ADDRESS : 30 LETCHER LN SUBDIV: PIONEER FARMS
 CONTRACTOR : WYNN CONSTRUCTION, INC. PHONE : (919) 528-1347
 OWNER : WYNN CONSTRUCTION INC PHONE :
 PARCEL : 13-0519- - -0119- -32-
 APPL NUMBER: 10-50023767 CP NEW RESIDENTIAL (SFD)
 DIRECTIONS : T/S: 02/11/2010 09:52 AM VBROWN ----
 30 LETCHER LANE, PIONEER FARMS SUB DVI
 #23 IN CUL DE SAC. OLD 421 10-12MI
 LEFT ON ADCOCK RD 1/4MI SUB DIV ON
 LEFT.

FIELD REPORT

Project LOT# 23 Pioneer Farms
 Location _____
 Client Buildcon's First Source
C/O Chuck
 Permits _____
 Task P.O # 10257357
 No. of Trips _____ Total Mileage _____
 Chargeable Equipment Used _____

AS REQUESTED, ECS, LTD Eng. PREPARED THIS REPORT TO ADDRESS THE FOLLOWING ITEMS:

Sheet # 1

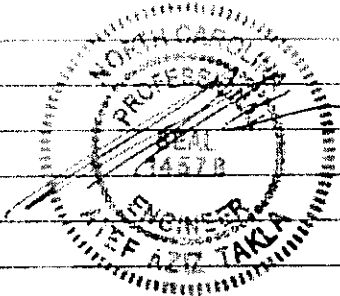
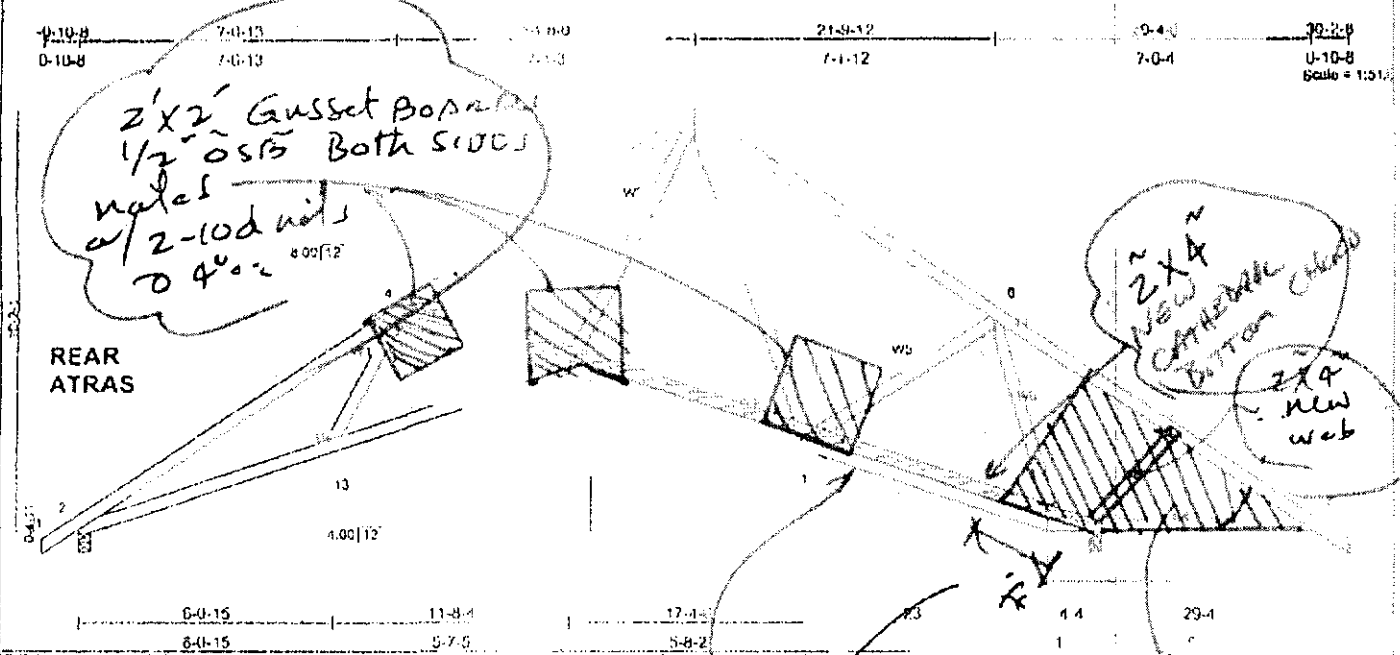
① Truss C1 REPAIRS are shown in attached sheet #1

OLD Bottom CHORD MUST BE CUT AWAY

1/2" OSB Gusset plate Both Sides nailed w/ 2-10d nails @ 4" o.c.

Sheet #2

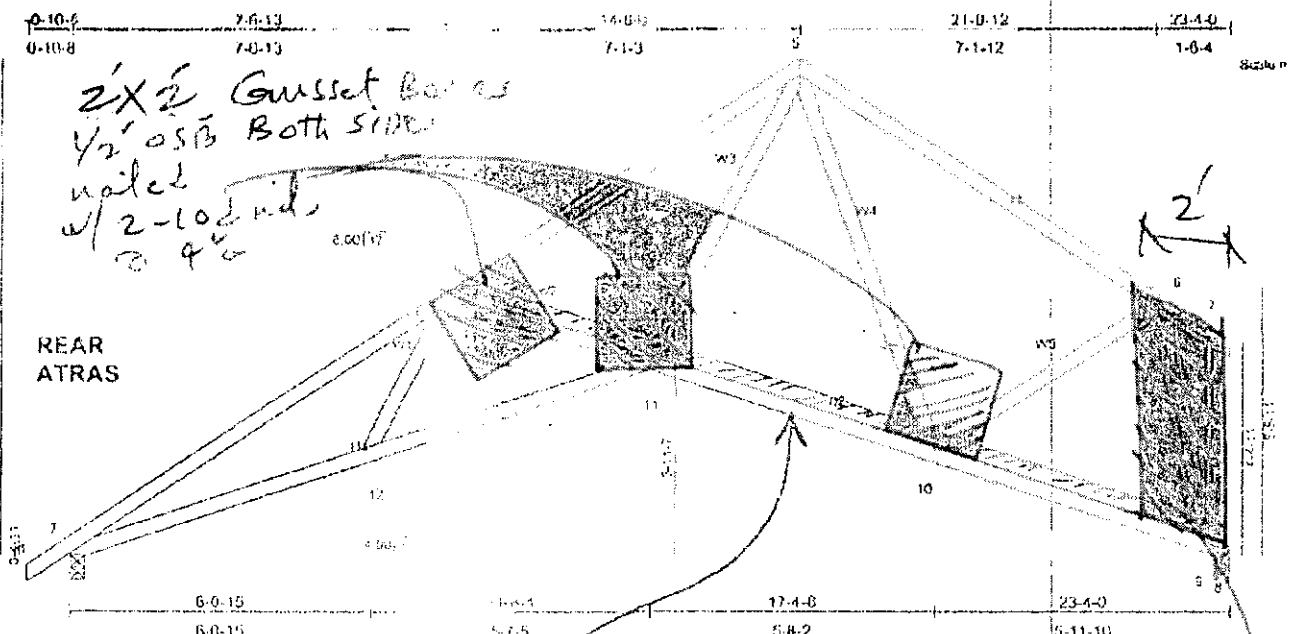
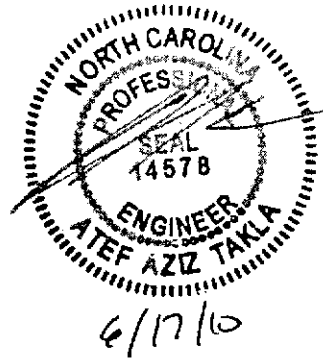
② Truss C2 repairs are shown in attached sheet #2

New Bottom cord
 2x4 TO
 Replace the
 cut original Batt.

2' wide
 1/2" OSB Gusset plates
 Both sides
 nailed w/
 2-10d nails @ 4"
